**From:** Sofie Fieldsend  
**Sent:** 27 May 2021 14:43  
**To:** Planning  
**Subject:** FW: 5 Belsize park Mews NW3 5BL - Planning Application 2021/0706/P  
**Attachments:** img333.pdf; BEL CR 210525 ROOFTOP B.pdf; img334.pdf

**Application 2021/0706/P**

I write on behalf of the owners of the garden flats at numbers 5 and 7 Belsize Crescent [BC] respectively with regard to the planning application for number 5 Belsize Park Mews [BPW] which backs directly onto Belsize Crescent as per the attached plan.

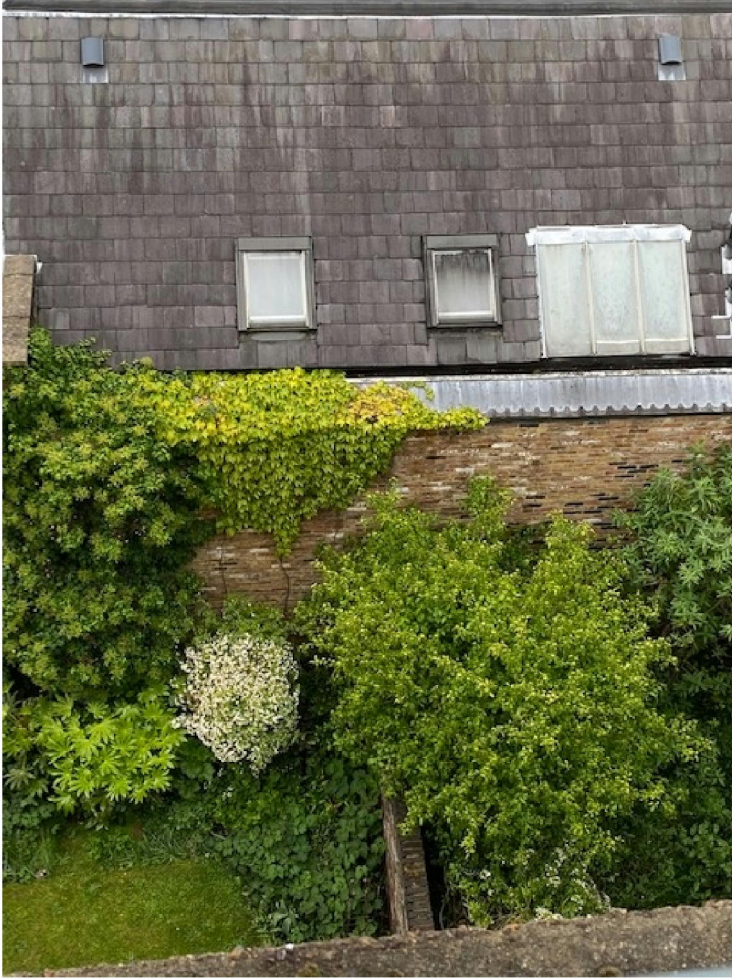
3 BPM is a strange extension but a completely different situation in relation to its neighbours with the current application. 9 BPM, having regard to its impact on the neighbours in BC, has a sloped roof of

approximately 45-50° rather than a vertical wall. Similarly, 7 BPM also has a sloping 3<sup>rd</sup> level from the boundary with its neighbours in BC. The attached photographs illustrate the properties identified.

There is **no** precedent in the Mews for a full storey above the existing 2<sup>nd</sup> floor, and can only reasonably be sustained by a compromised treatment to the rear boundary in the form of a sloping roof, as others have done.
